PLAT COMMITTEE April 12, 2023

Case Number: 2023-PLT-012

Request: Approval of a Subdivision Plat to be known as First Baptist Subdivision.

dividing 41.17 acres into four lots.

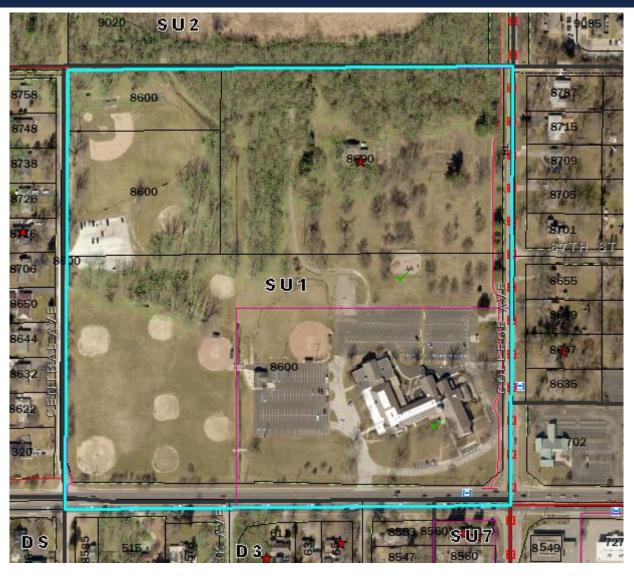
Sidewalks are existing along College Avenue and 86th Street. Sidewalks are required on Central Avenue.

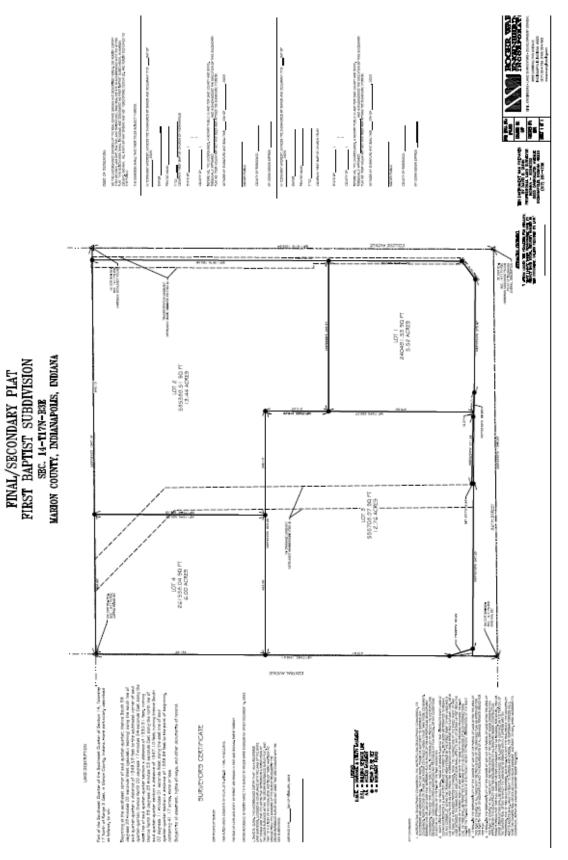
This site is zoned SU-1 and developed with a church building, surface parking, softball fields, and accessory structures. The proposed plat would subdivide the property into four lots. Lot One would be 5.52 acres and contain the existing church building on the southeast portion of the site. Lot Two would be 13.44 acres and contain the wooded areas and building on the northeast portion of the site. Lot Three would be 12.76 acres and contain the west parking area and softball fields, and the related accessory buildings on the southwest portion of the site. Lot Four would contain the softball field and parking area on the northwest portion of the site. The proposed plat meets the standards of the SU-1 zoning classification.

Staff recommends that the Plat Committee **approve** and find that the plat, file-dated February 24, 2022, complies with the standards of the Subdivision regulations, subject to the following conditions:
